HISTORIC AND DESIGN REVIEW COMMISSION

HDRC CASE NO: 2017-459
ADDRESS: 814 BURNET ST
LEGAL DESCRIPTION: NCB 549 (814 BURNET SUB'D {IDZ}), BLOCK 9 LOT 18
CITY COUNCIL DIST.: 2
DISTRICT: Dignowity Hill Historic District
APPLICANT: Felix Ziga/Ziga Architecture
OWNER: Poma Properties, LLC
TYPE OF WORK: Construction of four, two story residential structures
REQUEST:

The applicant is requesting conceptual approval to construct four, two story residential structures on the vacant lot at 814 Burnet.

Gaspar Rivera
Poma Properties, LLC
schematic design: proposed site / roof plan
1/16" = 1'-0"
10-11-17 - HDRC Conceptual - DRC Rev. 2

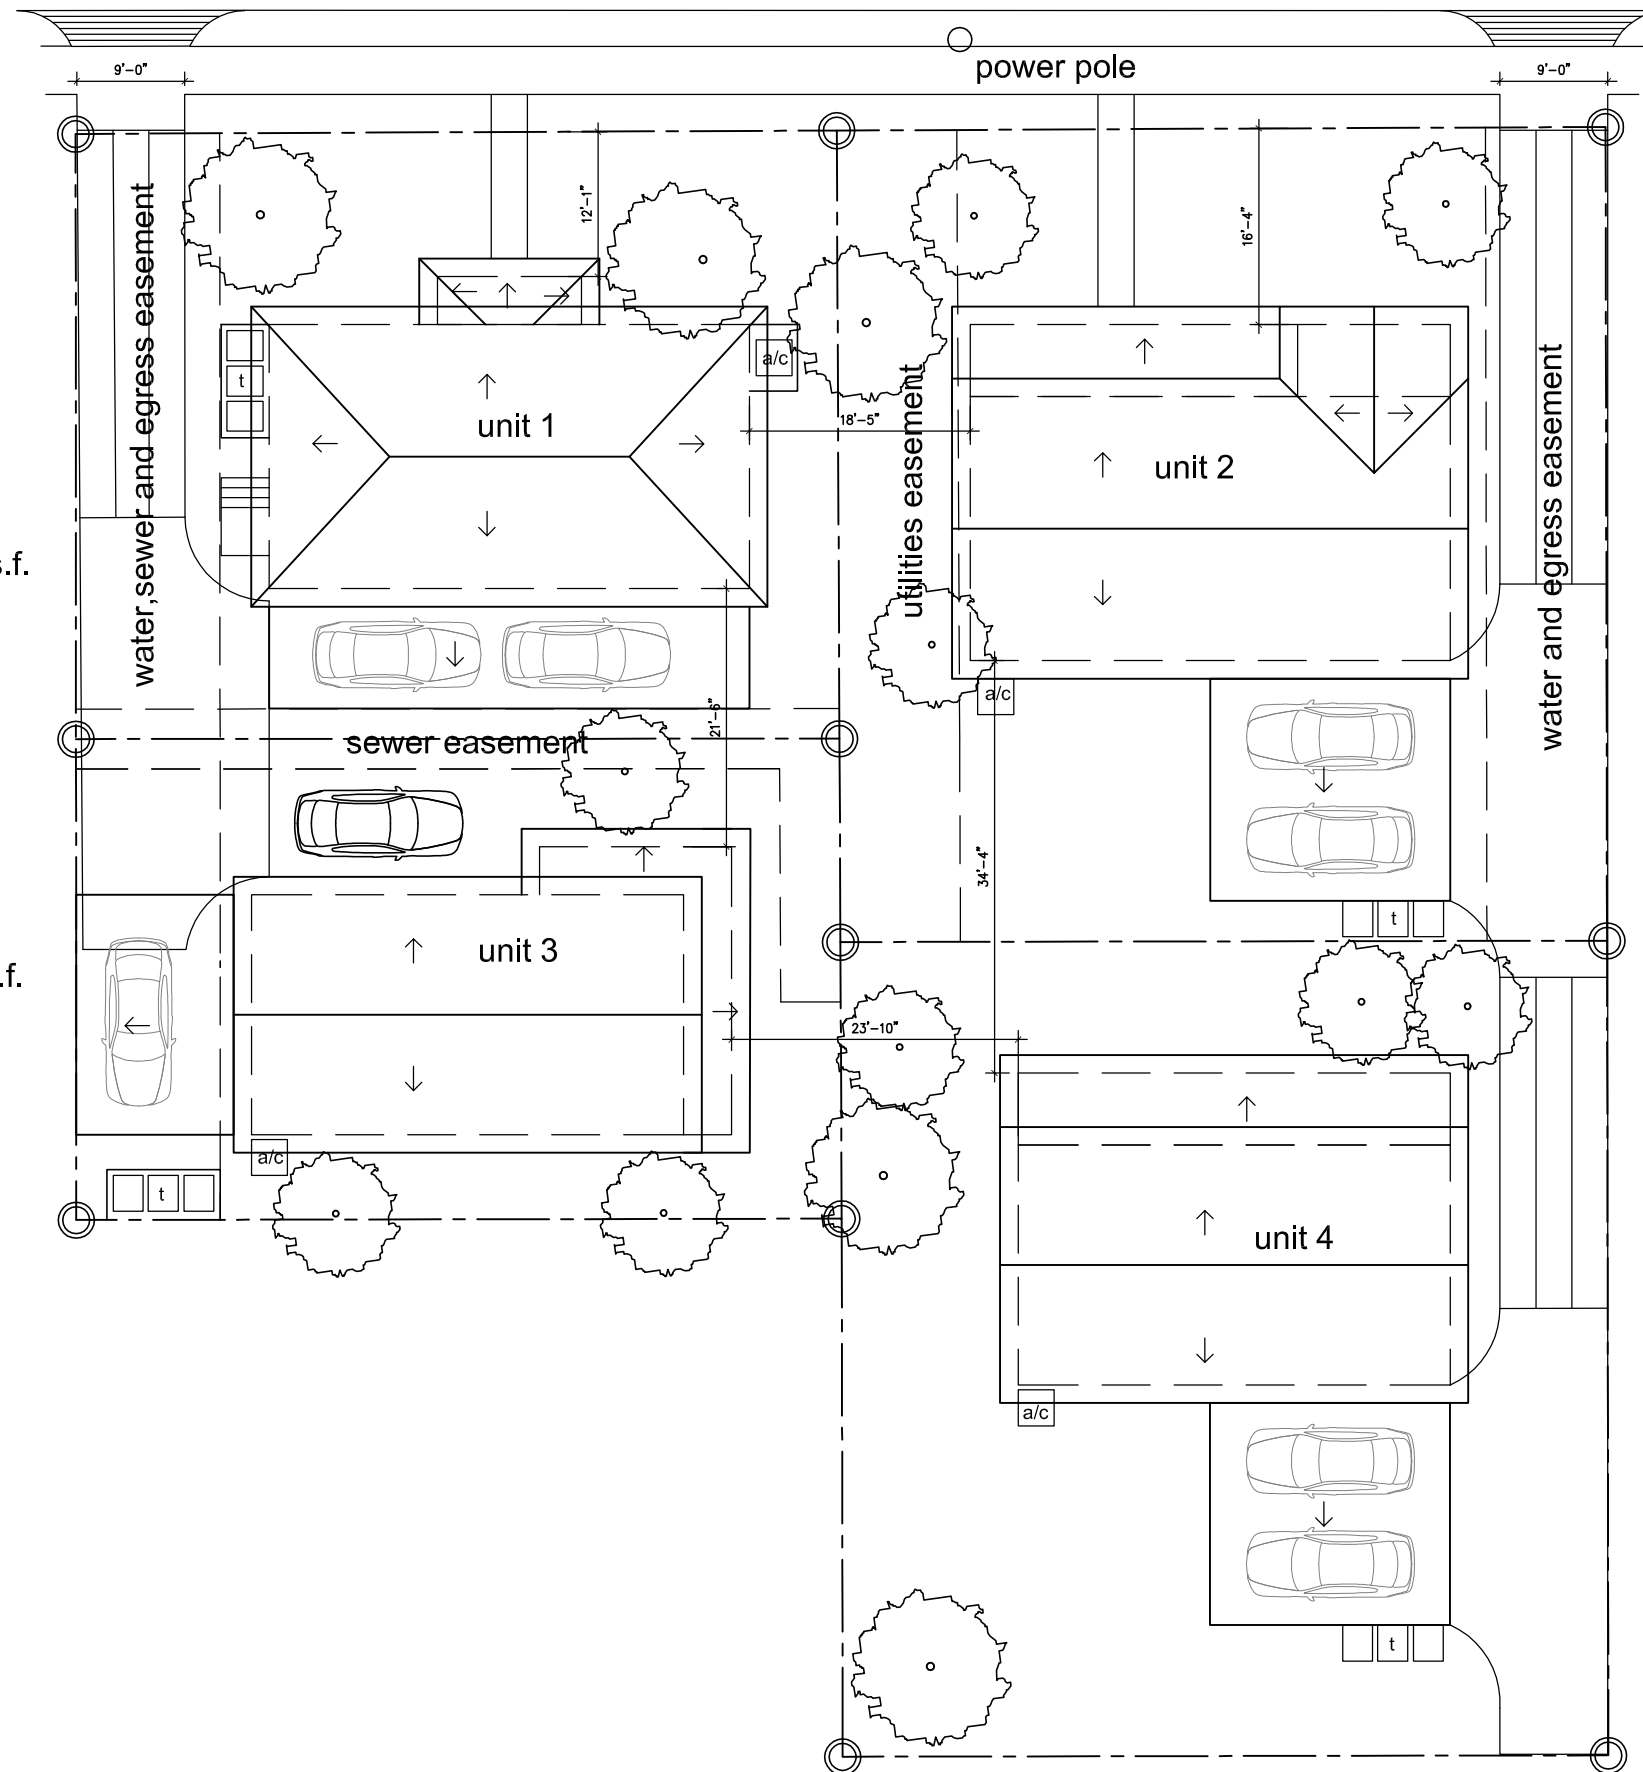
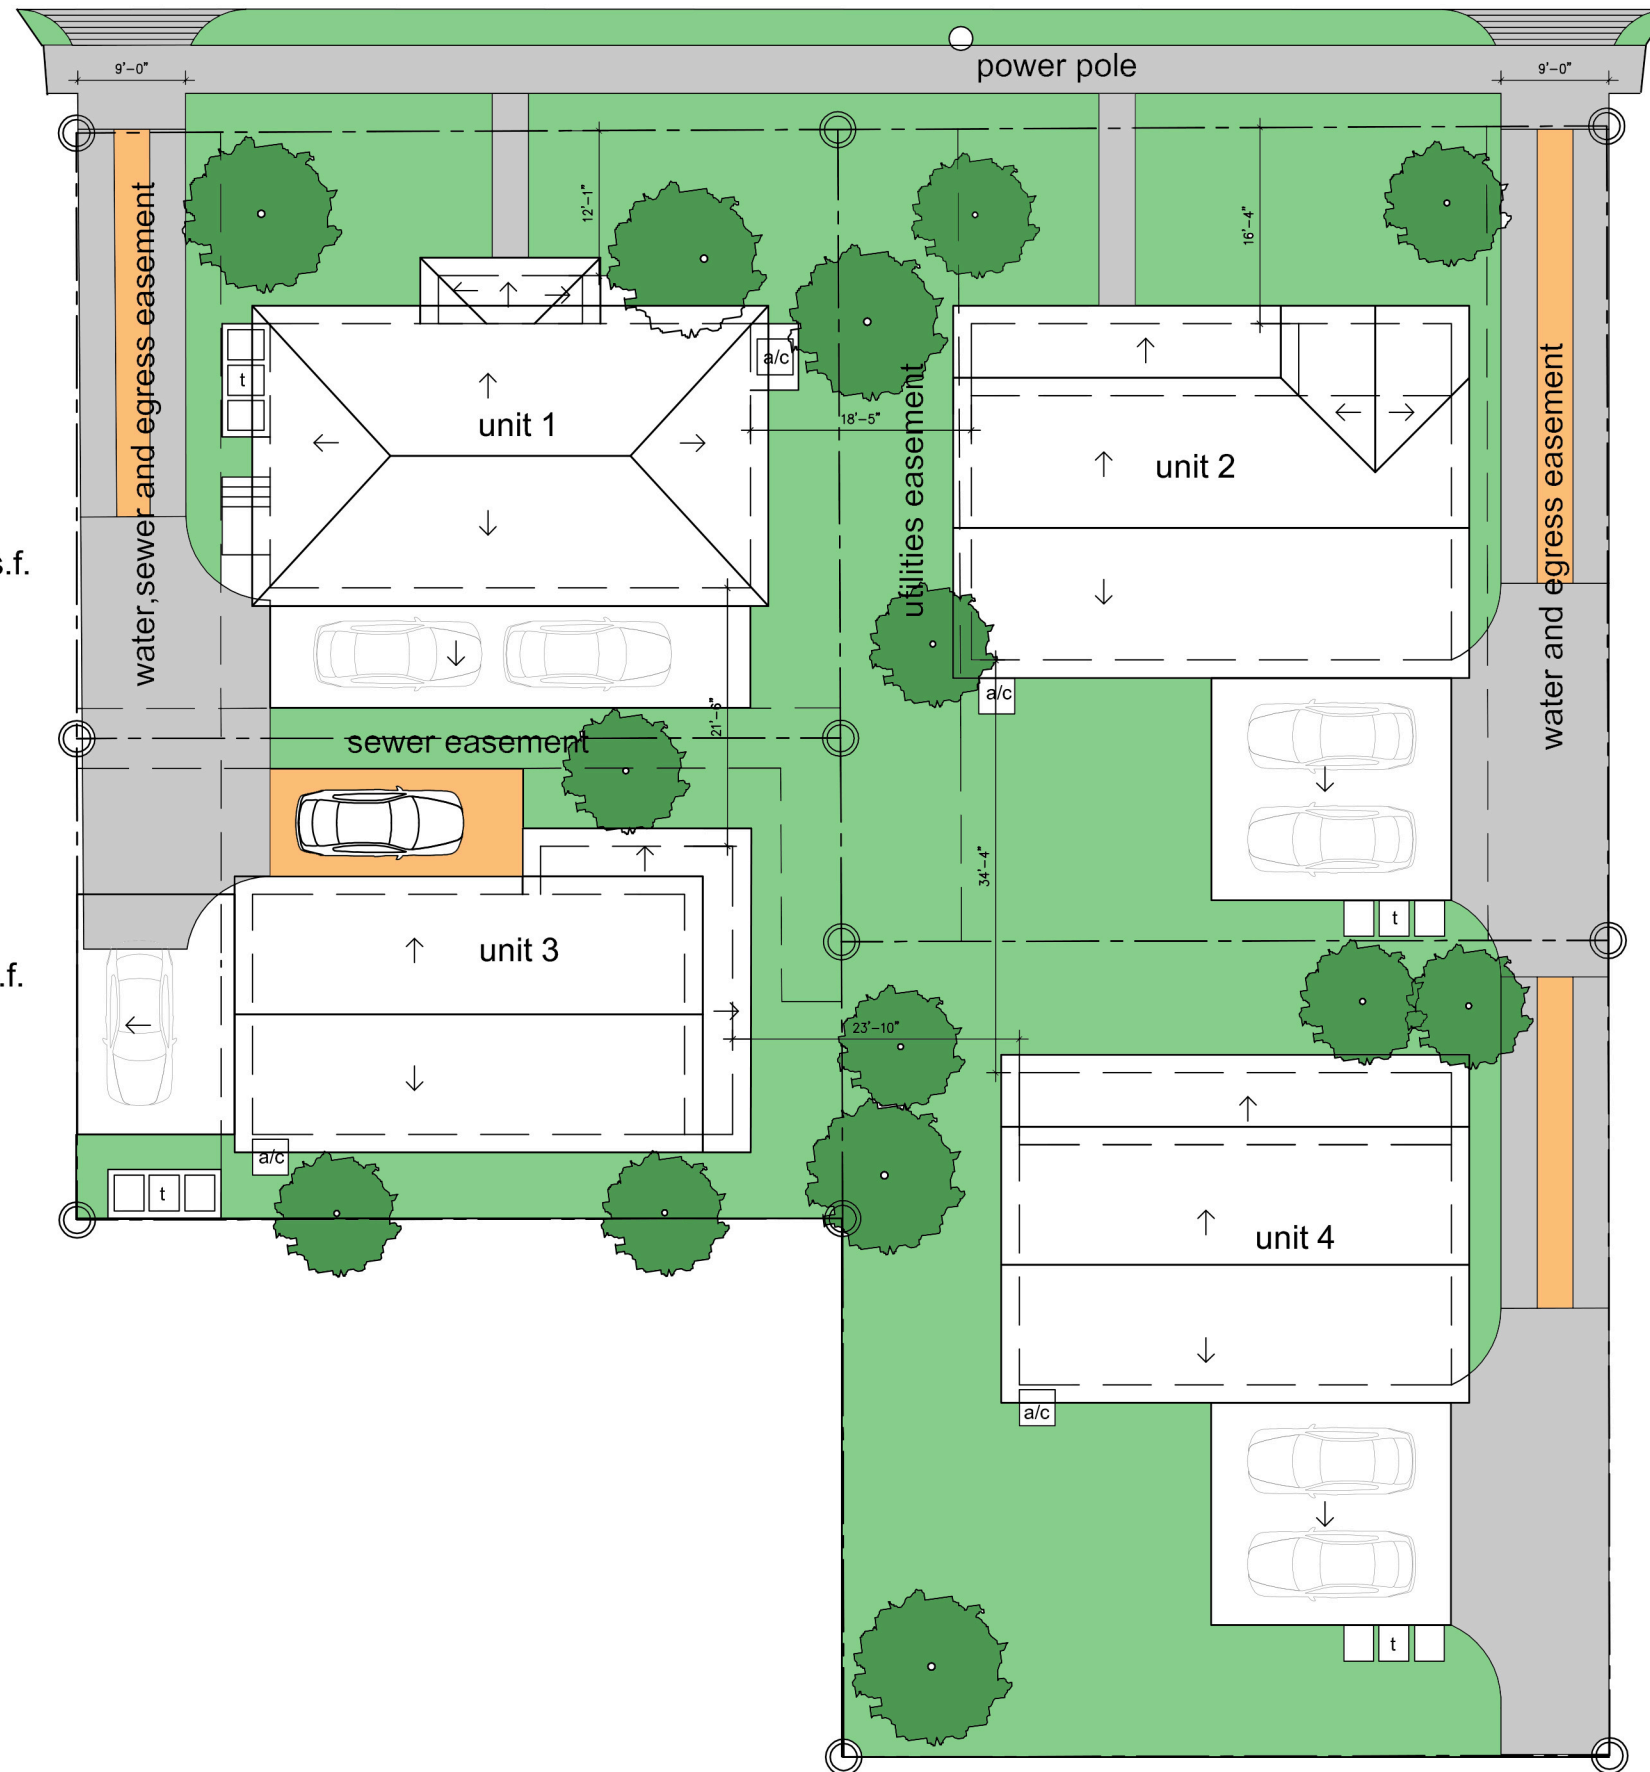
- s. SIDEWALK – The applicant has noted the installation of a front yard sidewalk for units 1 and 2; however, has not included these on the site plan. The proposed sidewalks should relate to those found historically in the district in terms of location, width and material and should be centered on the front porch of units 1 and 2.

- t. DRIVEWAY – On both the east and west sides of the lots, the applicant has proposed to install driveways to feature nine (9) feet in width. The Guidelines for Site Elements note that driveways should relate to historic driveways in the district and should not exceed (10) feet in width. The proposed driveways are consistent with the Guidelines. Staff finds the installation of two separate driveways located consistently with the pattern within the district is appropriate.

- v. LANDSCAPING – The applicant has noted the location of trees and driveways on the site plan; however, a detailed landscaping plan should be submitted to staff prior to submitting for final approval.

schematic design: street elevations

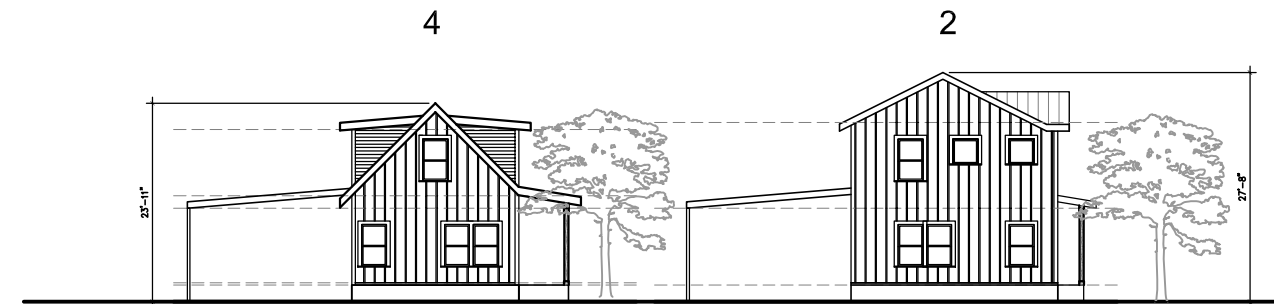
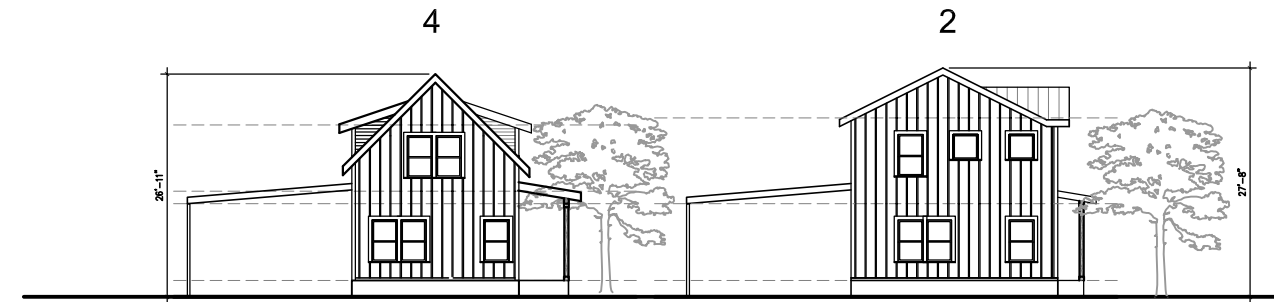
- h. SCALE & MASS – Per the Guidelines for New Construction 2.A.i., a height and massing similar to historic structures in the vicinity of the proposed new construction should be used. In residential districts, the height and scale of new construction should not exceed that of the majority of historic buildings by more than one-story. These two lots are located across Burnet from a two story historic structure and to the immediate west of a two story historic structure. Staff finds heights of two stories for units 1 and 2, that address Burnet is appropriate. At the rear of units 1 and 2, the applicant has proposed units three and four, which are also to feature two stories, but feature an overall height and mass that is subordinate to those of units 1 and 2. Staff finds this modified massing to be more appropriate than the previous proposal of four structures that each shared equal massing.

- i. SCALE & MASS – The applicant has noted overall widths of 43' – 0"; this measurement not only includes footprints, but also roof measurements. The applicant has noted that adjacent historic structures that front Burleson feature width of 40' – 11", 31' – 4" and 44' – 10". Staff finds the width of the proposed new construction to be inconsistent with the nearby historic structure given that the proposed widths are wider than all but one of the primary historic structures on this block that front Burleson.

- i. That the applicant minimize the massing and overall width of both units. Staff finds that both units should be reduced in width to be consistent with the majority of the widths of the historic structures on this block.

schematic design: proposed elevations - unit 1

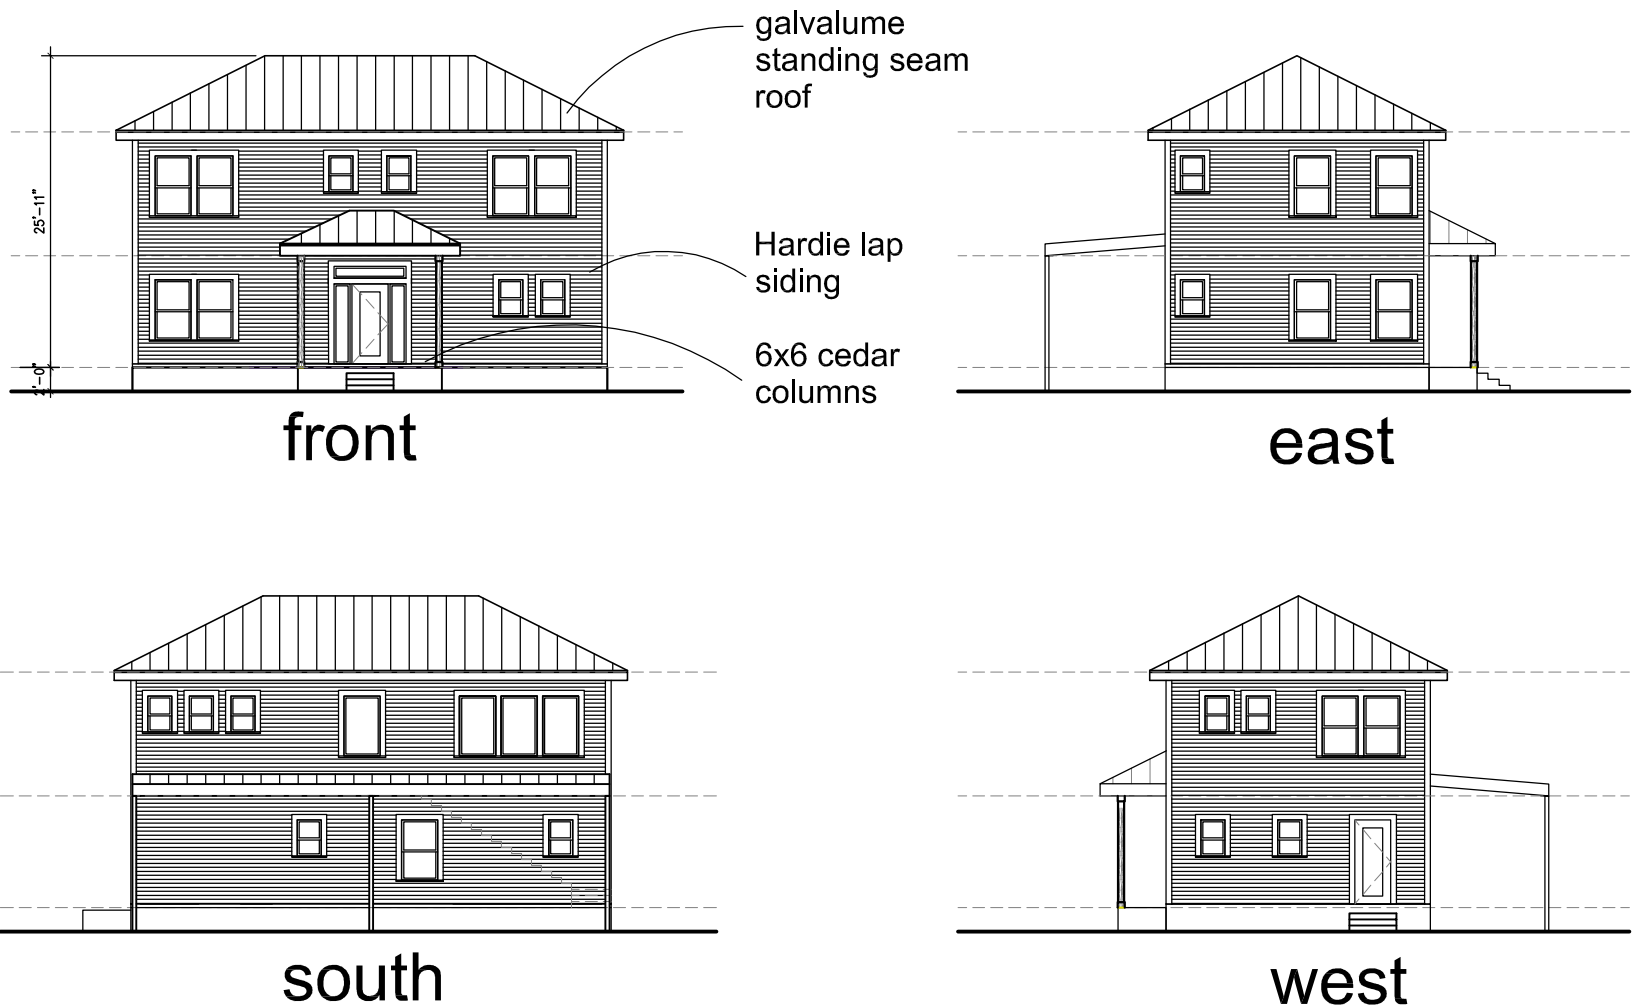
- k. ROOF FORM – The applicant has proposed for unit 1 to feature a hipped roof, unit 2 to feature a front and side gabled roof, unit 3 to feature a side gabled roof with front facing shed roofs and unit 4 to feature a roof form that matches that of unit 3. Gabled and hipped roofs are found throughout the Dignowity Hill Historic District. Staff finds the proposed roof forms of units 2, 3 and 4 to be appropriate. Staff finds the proposed roof form of unit 1 to be of a scale that is not found historically in the district.

- l. WINDOW & DOOR OPENINGS – Per the Guidelines for New Construction 2.C.i. window and door openings with similar proportions of wall to window space as typical with nearby historic facades should be incorporated into new construction. Generally the applicant has proposed window and door openings that are consistent with those found on historic structures throughout the district.

- o. ARCHITECTURAL DETAILS – New buildings should be designed to reflect their time while representing the historic context of the district. Additionally, architectural details should be complementary in nature and should not detract from nearby historic structures. Architectural details, such as well-proportioned porch elements, window coverings, roof eaves, and variations in wall planes add depth and visual interest and contribute to the overall quality of the design. Staff finds that revisions to the proposed design including the modification to roof forms for units 3 and 4 have improved the proposed architectural detailing. Staff finds that architectural elements that present a vertical emphasis should be used to improve the perceived proportions of units 1 and 2. Staff finds that window proportions should be elongated to further reflect those found on Folk Victorian structures and that transom windows should be added above each door opening.

- p. ARCHITECTURAL DETAILS – The applicant has proposed for each structure to have a covered porch which are designed as stoops with shed roofs. Staff recommends the applicant incorporate additional porch massing and work to include the design of the porches into the overall building’s mass.

- ii. That additional architectural detailing be added that is consistent with Folk Victorian detailing including window proportions that feature additional height, transom windows above each entrance, equal spacing between windows, and consistent relationships between solids and voids. The proposed short windows in bathrooms on the front façade should be eliminated and full height windows should be installed.
